# Tool & Product Update

## PINTAIL EJECTORS FOR INTERMEDIATE LENGTH NOSE ASSEMBLIES

Revised  
DATE 1-22-80  
NO. 183

ALTERATION DIMENSIONS TO CONVERT:

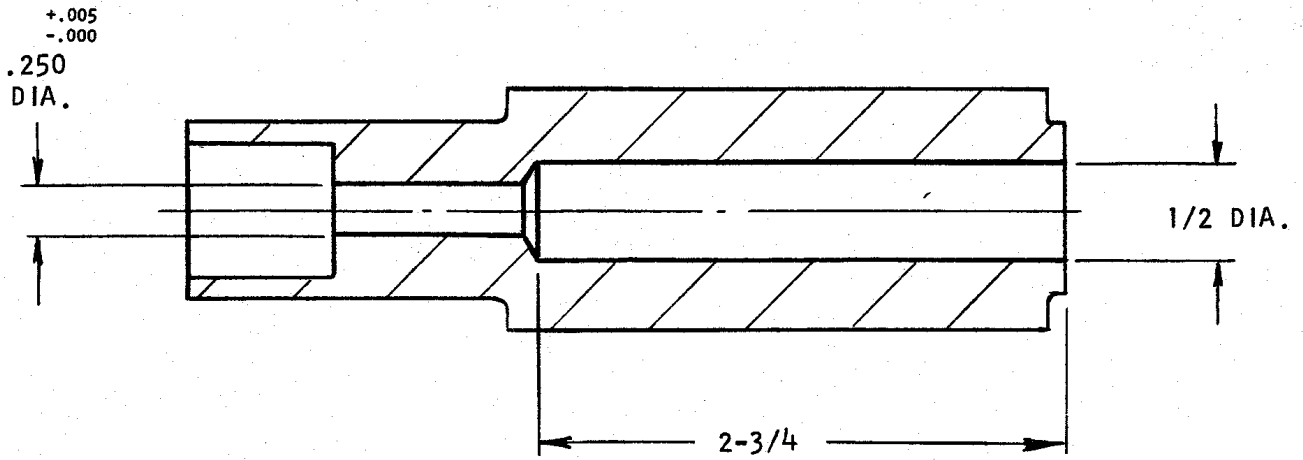
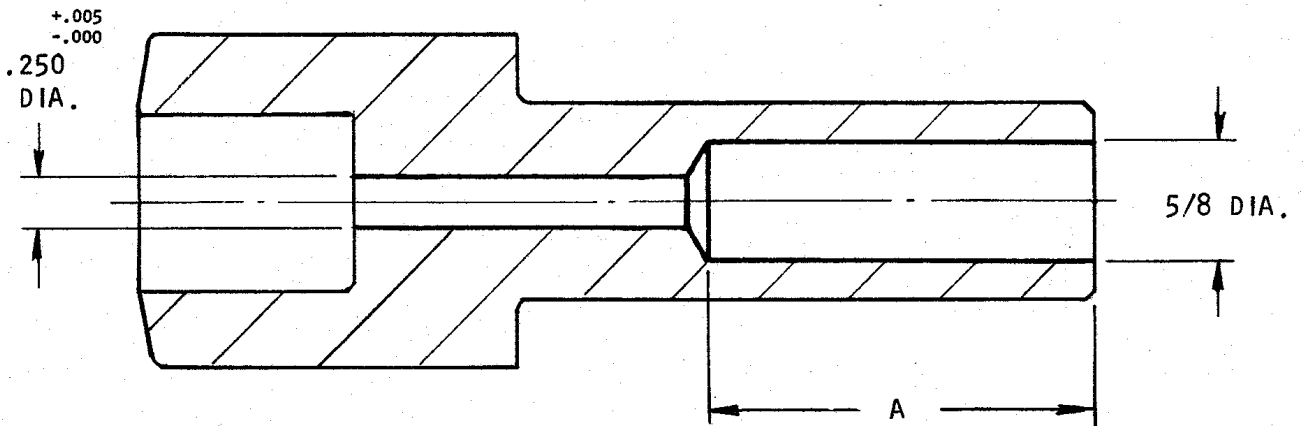
For replacements in earlier intermediate length nose assemblies, order the appropriate current pintail ejector and follower sleeve. Earlier follower sleeves may be altered as shown on the other side of this sheet.

P/N 110801 TO P/N 112223  
P/N 110794 TO P/N 112219

P/N 109988 TO 112224; A=1-3/4  
P/N 109954 TO 112222; A=2-1/4
